## 2024/0959/P

The application proposes to replace the lower ground floor rear sash window with a 'four-panel glazed arrangement with central opening doors, this would be a metal framed style design with narrow section framing in steel and powder coated.'

Proposed 2024/0959/P

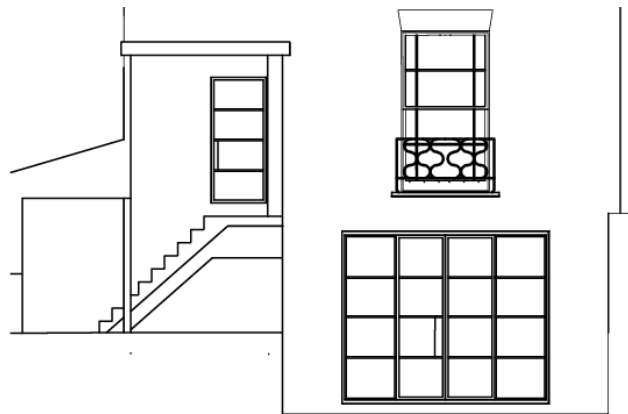
The lower ground floor sash window and gauged brick arch would be a significant loss to the Regency design of the rear elevation.

The proposal picture shows a rectangle of 16 panes and considers it will have little visibility – although there are 3-storey houses behind Bartholomew Road. More information on the design, to match the Regency above, would be welcome.

The balcony on the first floor is represented with three-panel sash window, welcomingly more interesting and found elsewhere around Rochester Terrace Gardens, yet the 'existing' (as of 2009 photo) shows paned double doors. What is proposed?
